SUBJECT: ISSUANCE OF AMENDMENT NO. 100 TO FACILITY OPERATING LICENSE
NO. NPF-12 REGARDING REQUIRED SHUTDOWN MARGIN - VIRGIL C. SUMMER
NUCLEAR STATION, UNIT NO. 1 (TAC NO. 79683)

Amendment No. 100
License No. NPF-12

SAFETY EVALUATION BY THE OFFICE OF NUCLEAR REACTOR REGULATION
RELATED TO AMENDMENT NO. 100 TO FACILITY OPERATING LICENSE NO. NPF-12
SOUTH CAROLINA ELECTRIC & GAS COMPANY
SOUTH CAROLINA PUBLIC SERVICE AUTHORITY
VIRGIL C. SUMMER NUCLEAR STATION, UNIT NO. 1
DOCKET NO. 50-395

FIGURE 3.1-3
 REQUIRED SHUTDOWN MARGIN
 (MODES 3, 4, AND 5)

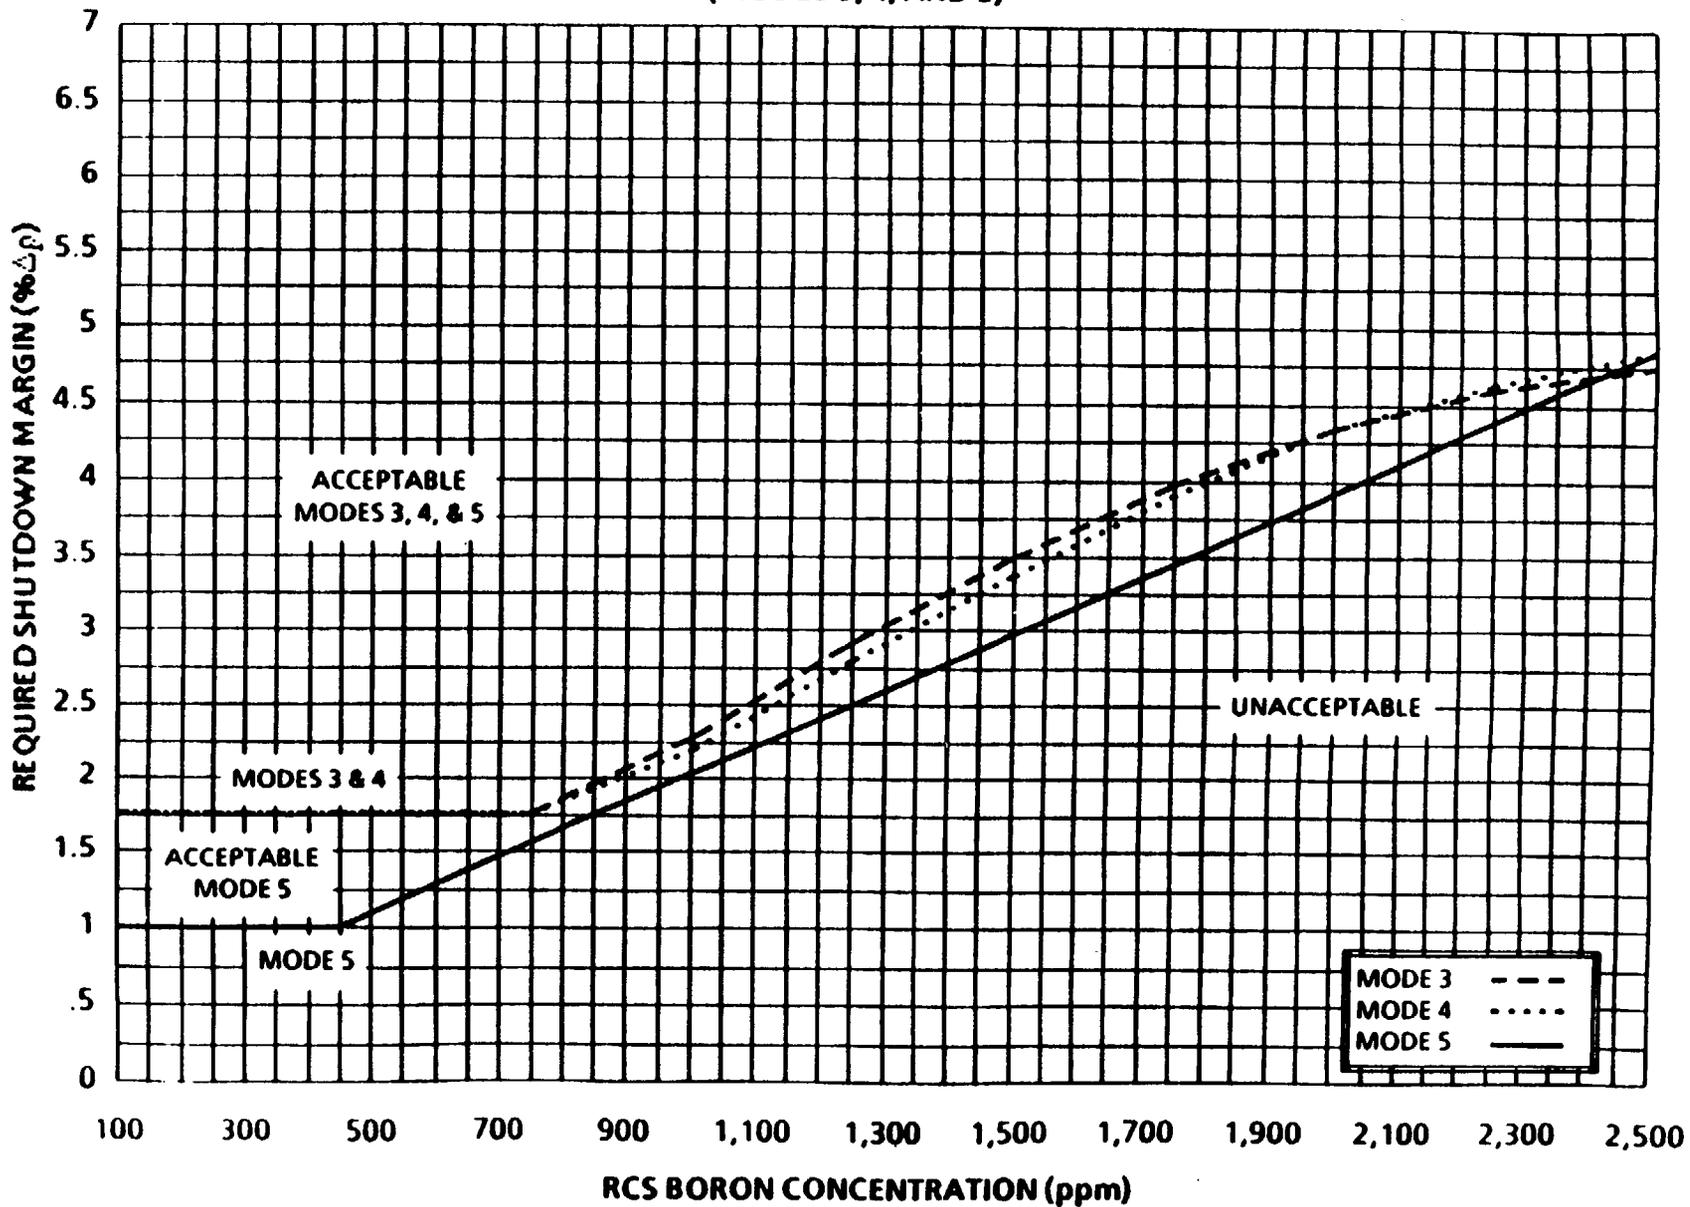
The proposed amendment changes the Technical Specifications to revise Figure 3.1-3, "Required Shutdown Margin (Modes 3, 4 and 5)," to incorporate the more negative boron worths associated with the Cycle 6 core and subsequent cores. In addition, an administrative change was included in the change request to revise Basis 3/4.2-1, "Axial Flux Difference," to refer to the Core Operating Limits Report rather than the Peaking Factor Limits Report.

By letter dated February 4, 1991, South Carolina Electric and Gas Company (SCE&G or the licensee) submitted a request for changes to the Virgil C. Summer Nuclear Station, Unit No. 1 (Summer Station), Technical Specifications (TS). The requested change would revise Figure 3.1-3, "Required Shutdown Margin (Modes 3, 4 and 5)," to incorporate the more negative boron worths associated with the Cycle 6 core and subsequent cores. In addition, an administrative change was included in the TS change request to revise Basis 3/4.2-1, "Axial Flux Difference," to refer to the Core Operating Limits Report (COLR) rather than the Peaking Factor Limits Report (PFLR).

Figure 3.1-3 specifies the shutdown margin that must be maintained for varying reactor coolant system (RCS) concentrations of boron in order to (1) control, within acceptable limits, the reactivity transients associated with postulated accident conditions; and (2) maintain the reactor sufficiently subcritical to prevent inadvertent criticality.

For Cycle 6, however, the boron worths for Modes 3 and 4 were calculated to be more negative than the values assumed in the current boron dilution accident analyses. The more negative boron worth reduces the required change in boron concentration necessary to achieve criticality during a dilution event and results in a reduction in operator action time of approximately two minutes. To resolve this problem, SCE&G has proposed to revise the TS shutdown margin curve for Modes 3 and 4 to reflect the larger required shutdown margin to ensure that the operator action time to detect and terminate an inadvertent

boron dilution event is not reduced. These higher shutdown margin requirements will require higher boron concentrations to be maintained while in Modes 3 and 4 of the fuel cycle. Since the boron worth for Mode 5 was determined to be bounded by previously analyzed values, the Mode 5 curve was not changed from the one currently in the TS.

The requested change is acceptable because the proposed shutdown margin curves were developed using the same approved methodology used to develop the current curves. In addition, the current margin to criticality, as reflected in the Final Safety Analysis Report of the boron dilution accident, will be maintained. Based on the above considerations, the staff finds the proposed changes acceptable.
